**Noises in the Rear Seat Well**

Vehicle Type: **911 Turbo (996)**

Model Year: **MY 2001 (1)**

Concern: **Noises in the rear seat well area due to relative movements of the transverse reinforcement tube.**

**Figure 1**

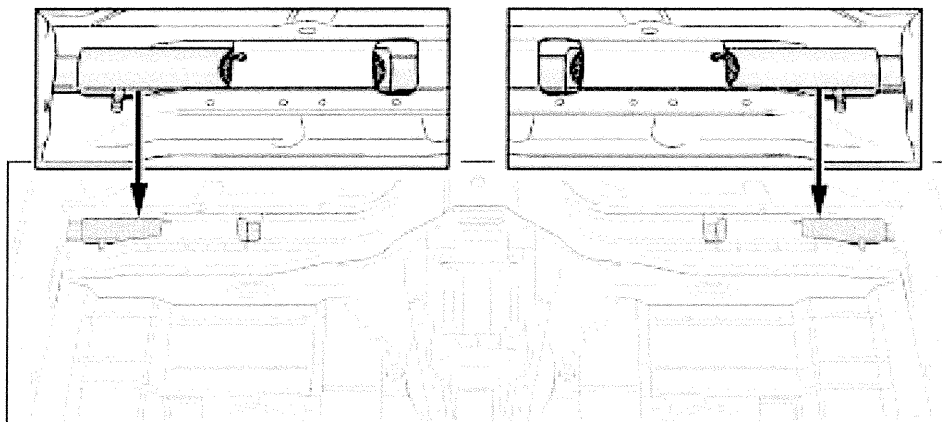
Information: An additional transverse reinforcement tube has been installed in the rear seat well area. See figure 1. During driving the relative movement of the reinforcement tube may come into contact with the rear seat well panel. This condition may result in audible "clinking" type noises.

To eliminate the noise, felt tape has been installed in new vehicles between the reinforcement tube and the rear seat well panel. The felt tape was installed in production on May 14, 2001 from the following VIN:

If a customer complains of "clinking noises in the rear seat well area", felt tape can be installed on vehicles that fall within the VIN range indicated above.
